WATERBURY FILING NO. 1

CONSTRUCTION SET

GRADING AND EROSION CONTROL PLAN

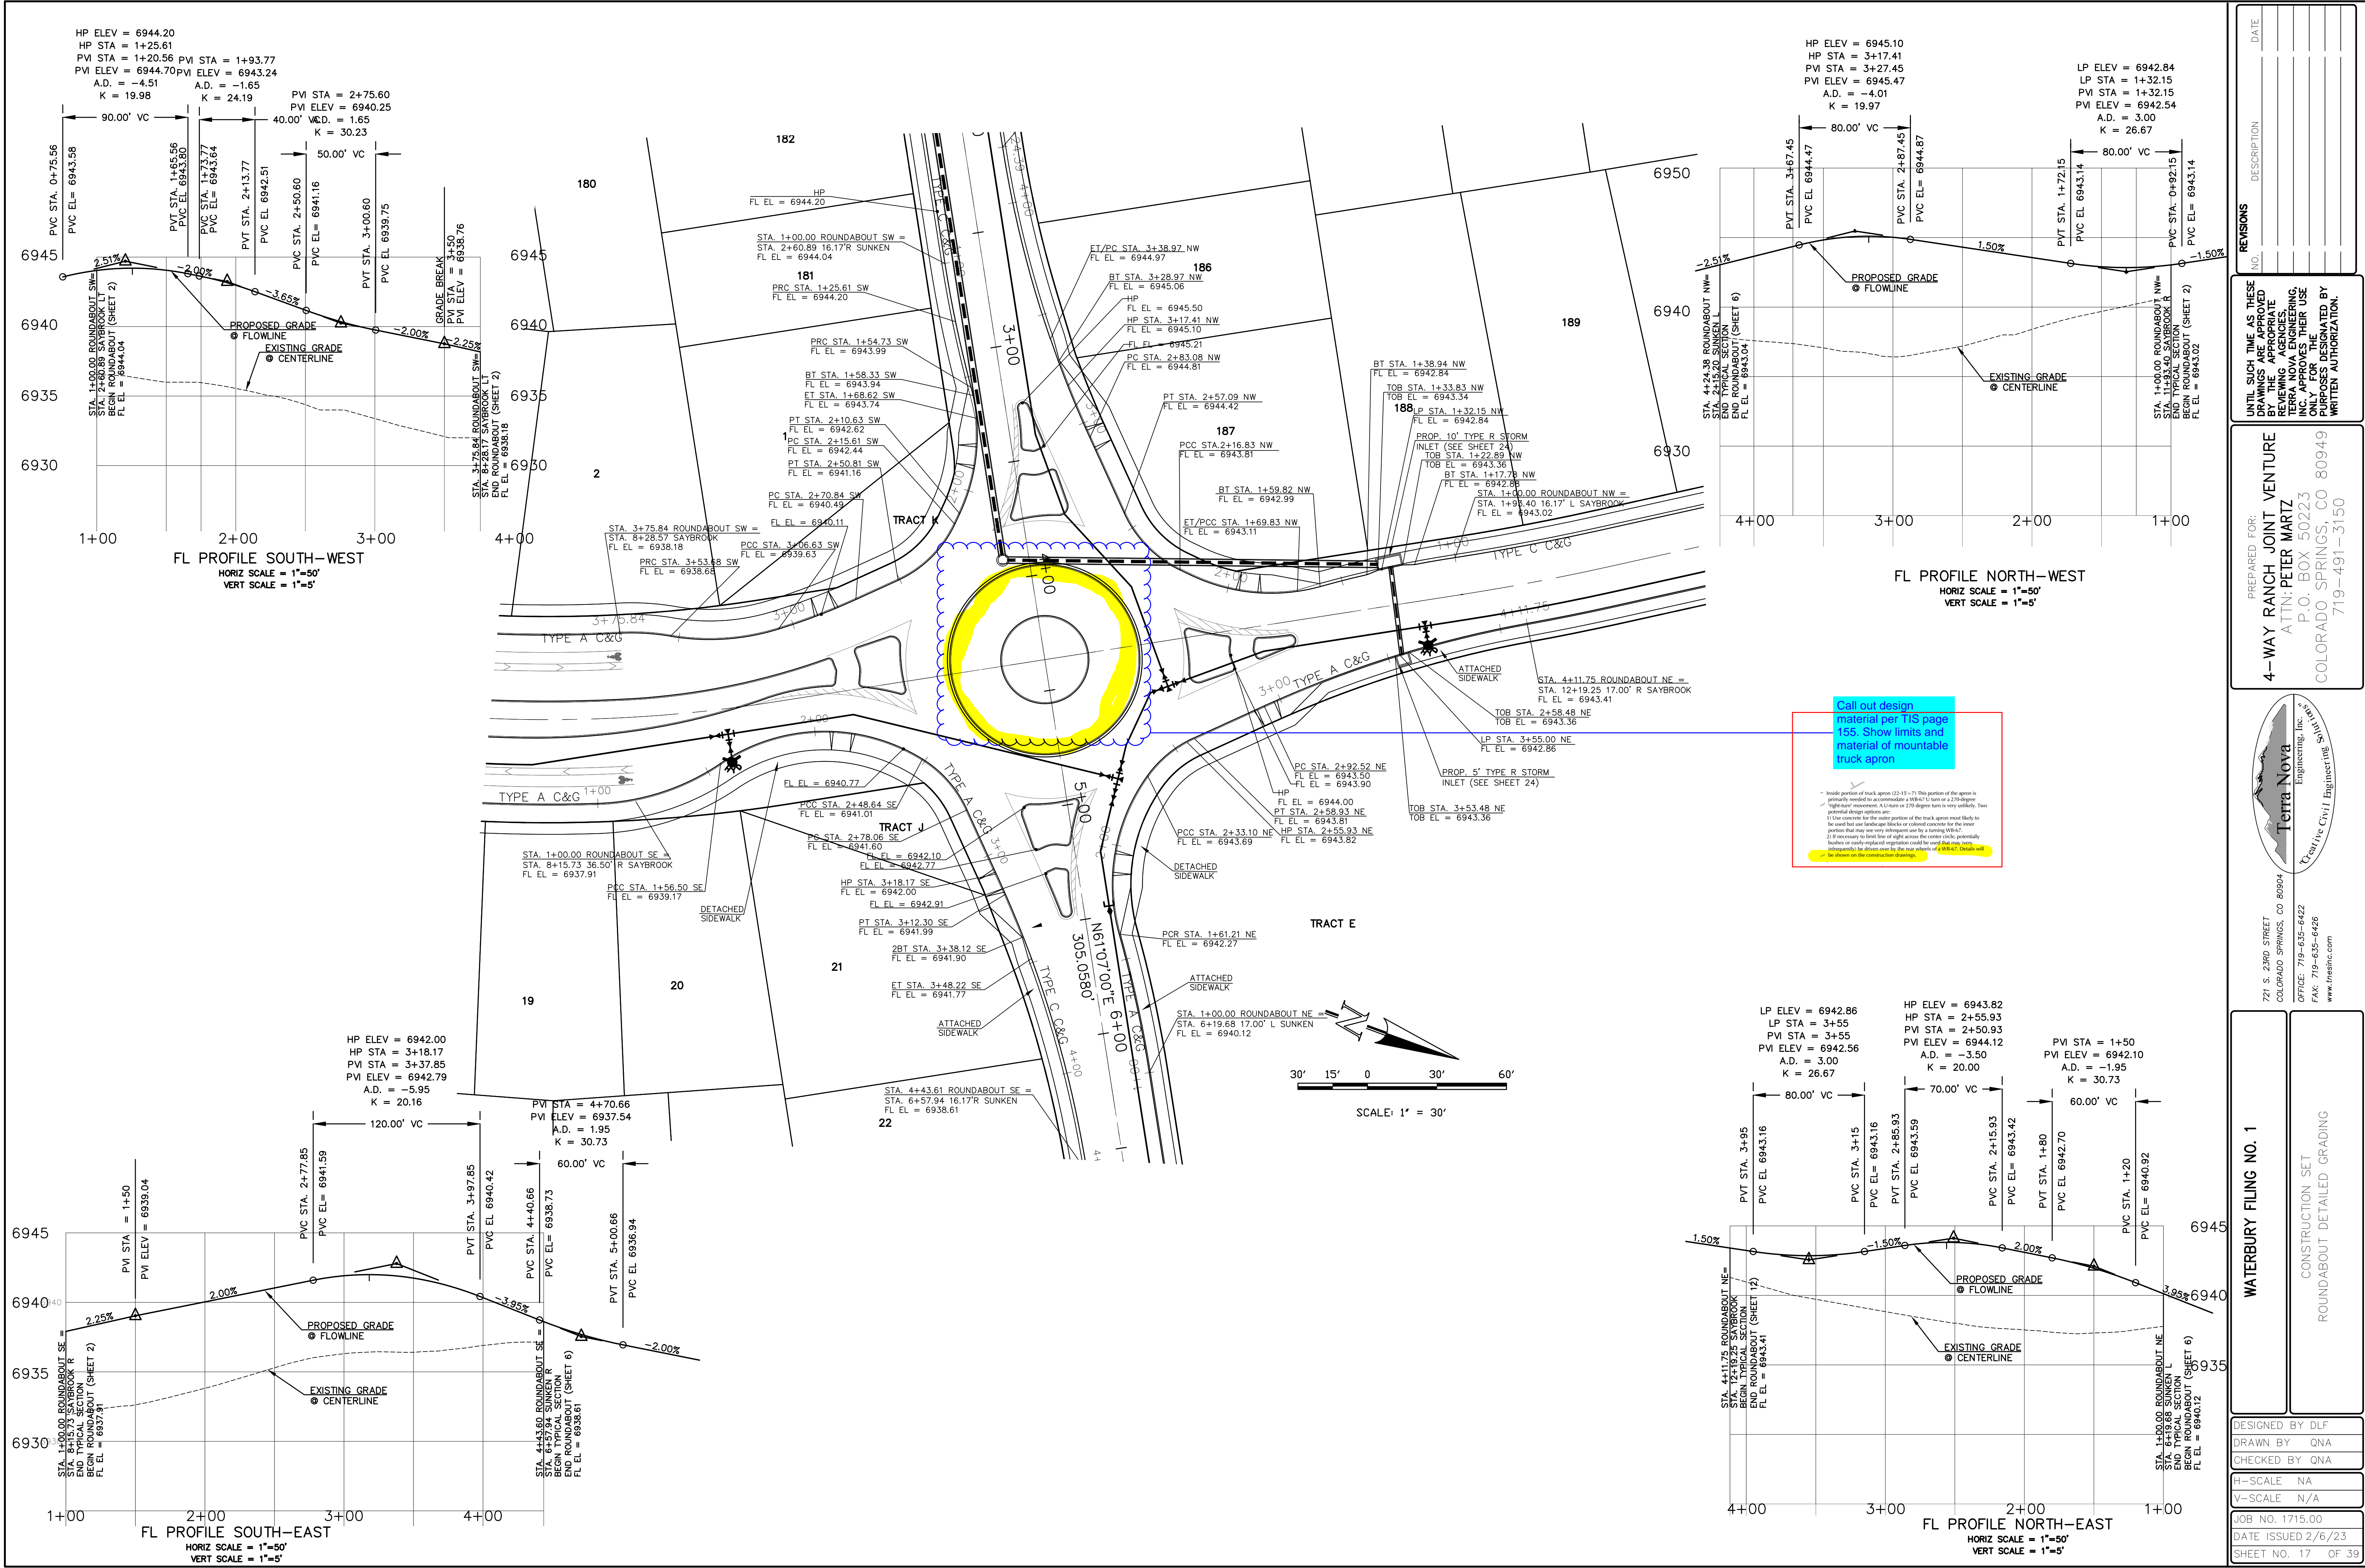
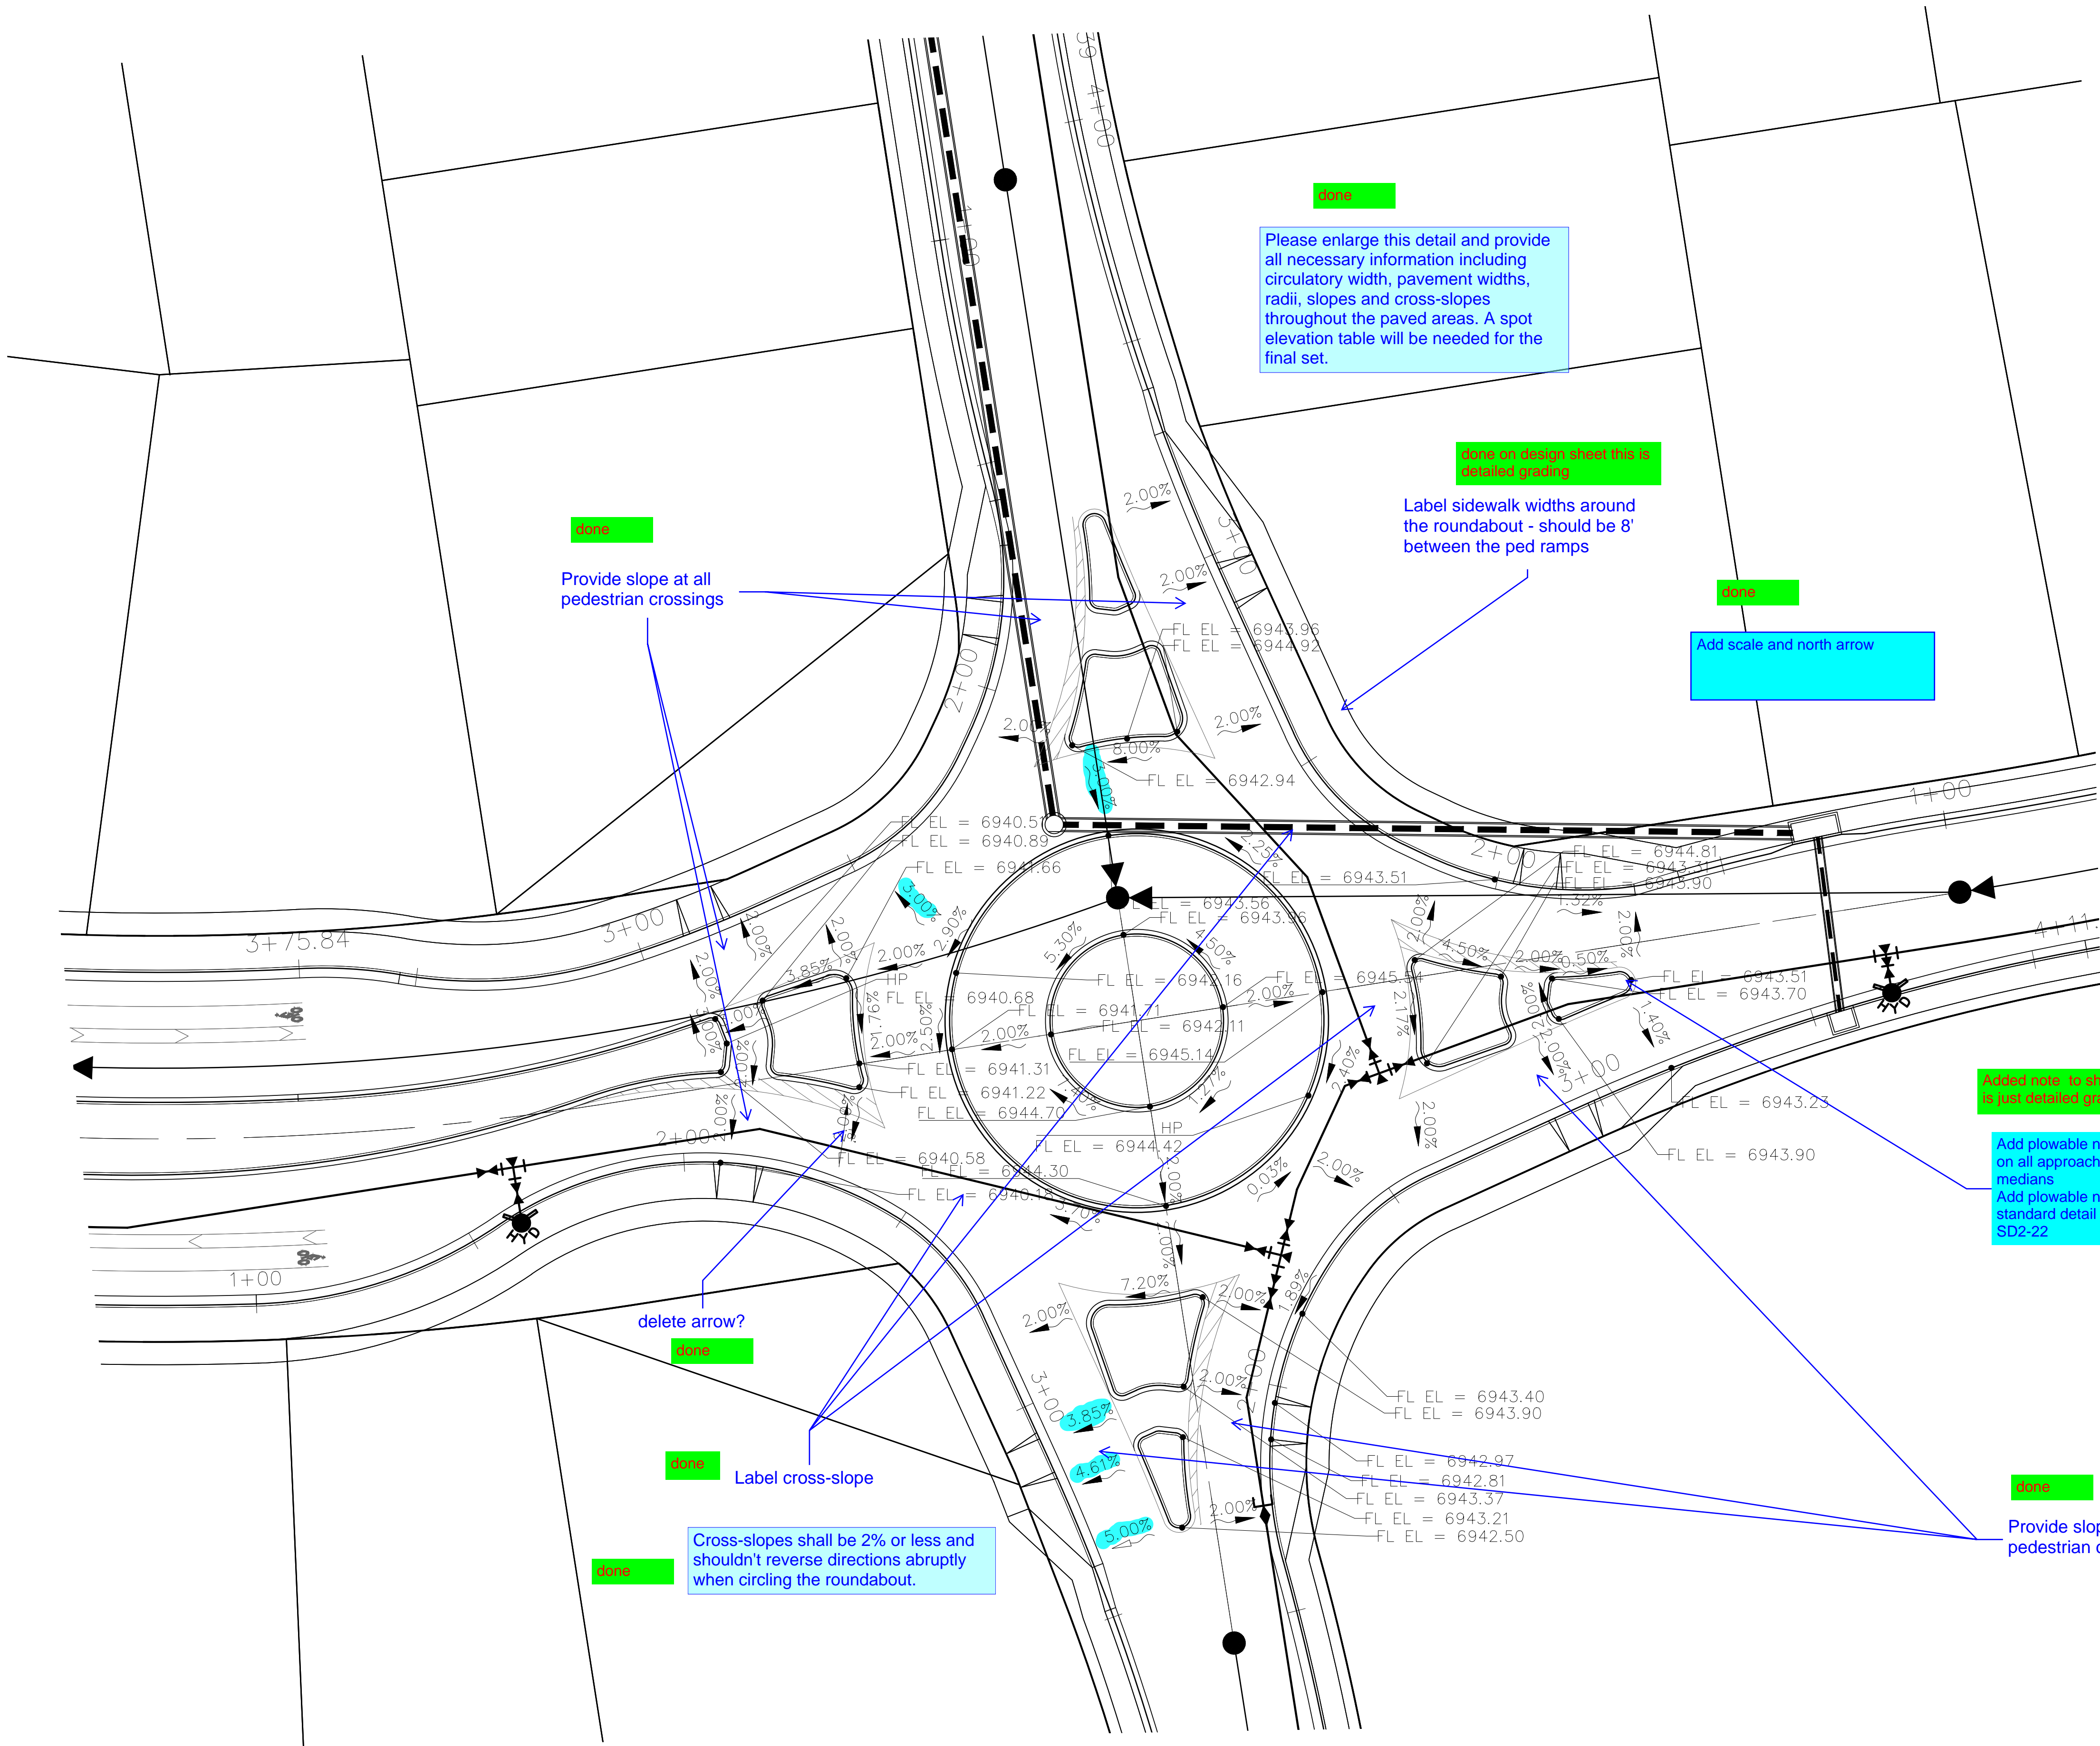
Call out design material per TIS page 155. Show limits and material of mountable truck apron
